Representations to Kenilworth Development Brief

Prepared on behalf of Barwood Land

Representation to Kenilworth Development Brief

Project Ref:	29543
Status:	Final
Issue/Rev:	V1
Date:	14 th January 2019
Prepared by:	KV
Checked by:	KV
Authorised by:	KV

DRAWING TITLE
 Proposed Site Access

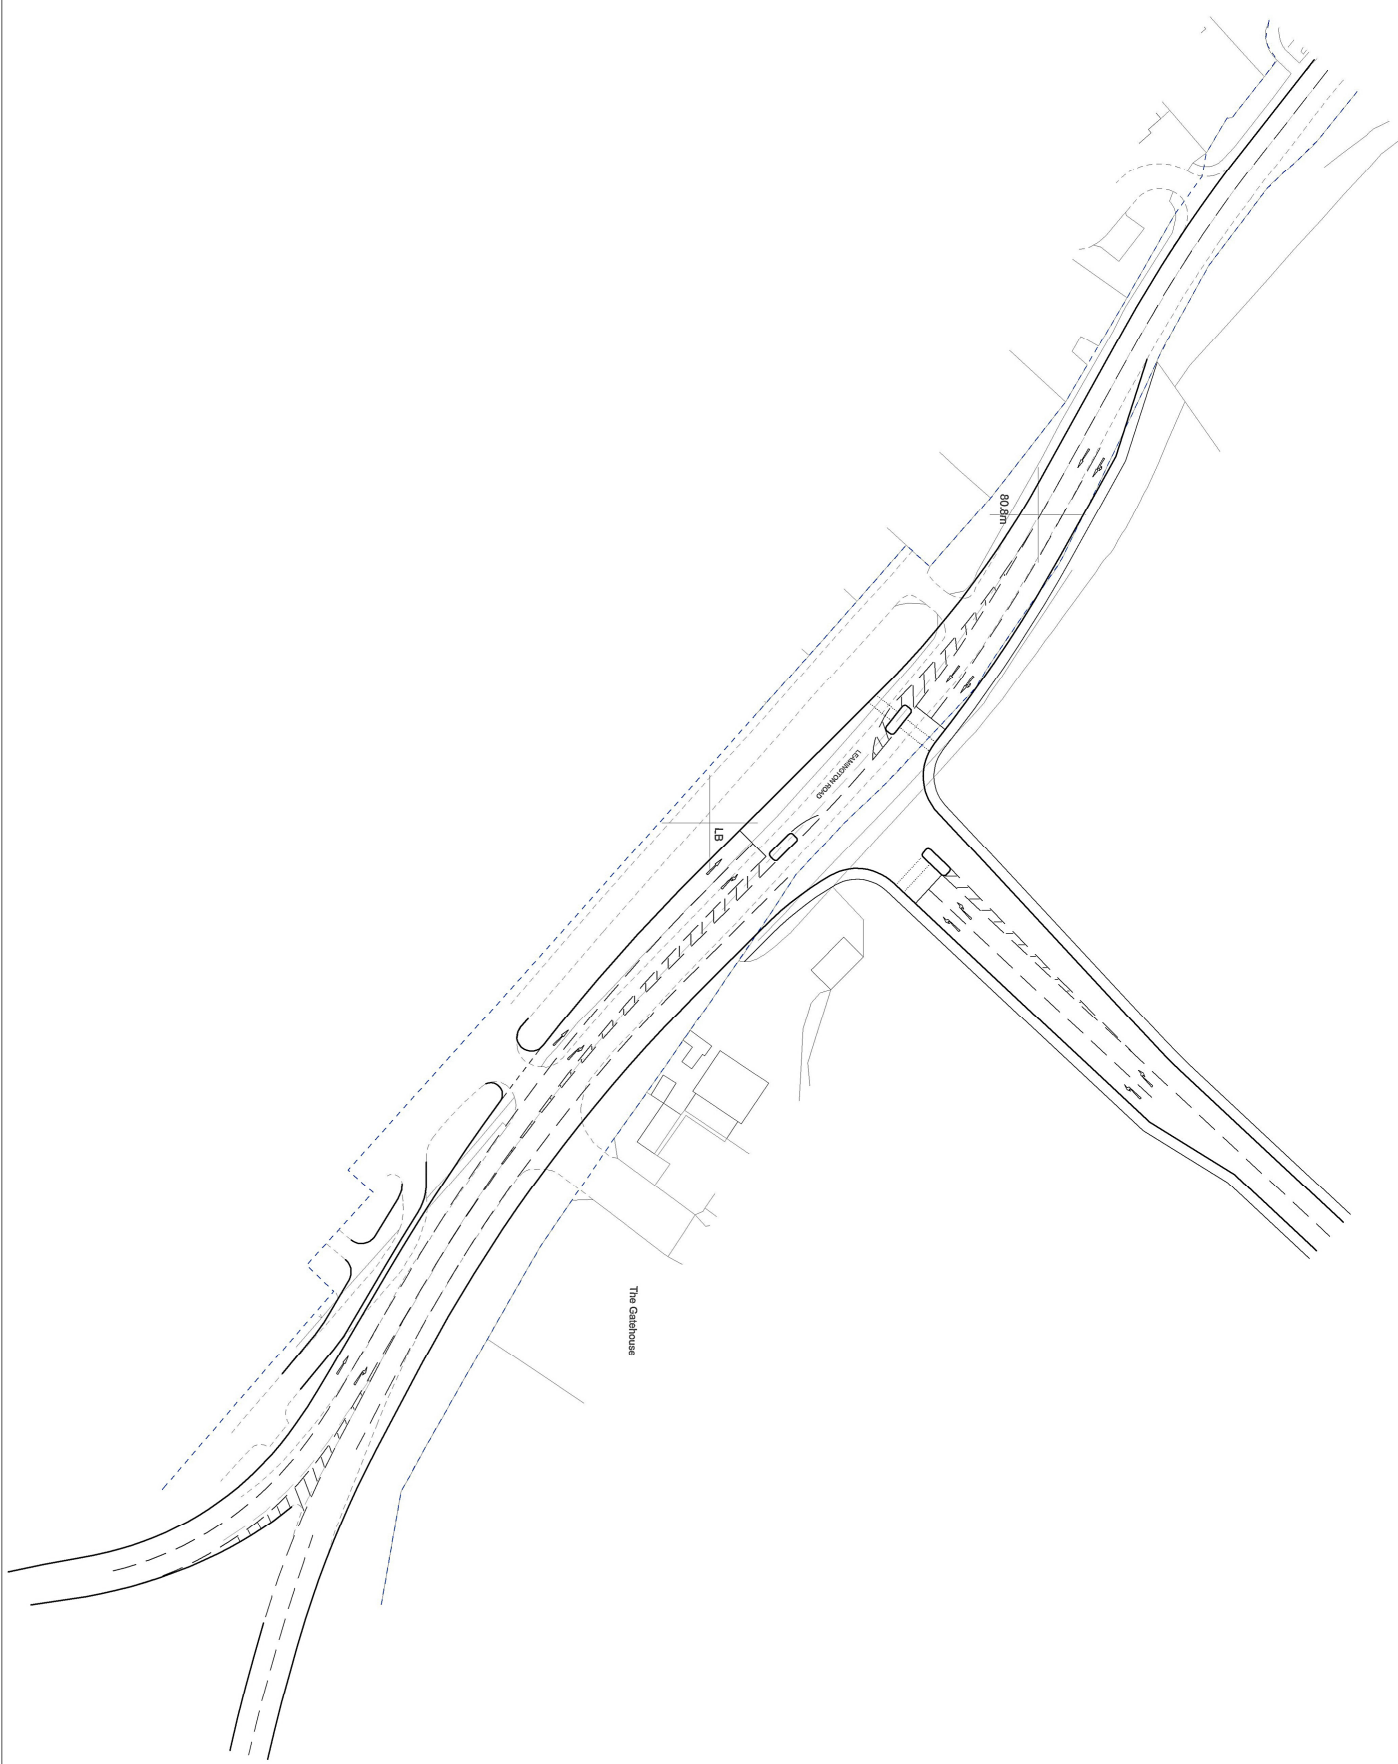
- 2.10 Consideration has therefore been given to the provision of a signal-controlled junction formed between the spine road and the A452 Leamington Road providing access to both the employment and residential allocations. The employment access would form a junction with the spine road a short distance into the site to separate the residential and employment traffic and minimise the interaction between the two elements of the development.

- 2.11 A preliminary layout for this option has therefore been designed and subjected to capacity testing by PJA. A copy is enclosed at **Appendix 2**.

2.14 The above traffic flows have been assessed for the signal-controlled junction shown in Drawing 3140-01 included at Appendix A. The junction has been modelled in LinSig V3 and the results are presented in Table 2.

2.15 The junction is forecast to operate at approaching theoretical capacity thresholds.

2.16 The above modelling does not include signal-controlled pedestrian crossing facilities. Due to the likely demand however, a signal-controlled facility would not be required across Leamington Road in the vicinity of the junction. Instead, an uncontrolled facility would be appropriate. This facility would have tactile paving/dropped kerbs to denote the

crossing point and a pedestrian refuge area. To the north of the junction where there is likely to be a higher pedestrian demand, a signal-controlled facility would be provided.

- 2.17 In terms of crossing facilities across the spine road, it would be possible to provide a staggered crossing which could be staged with traffic thus would not affect the operation of the junction.
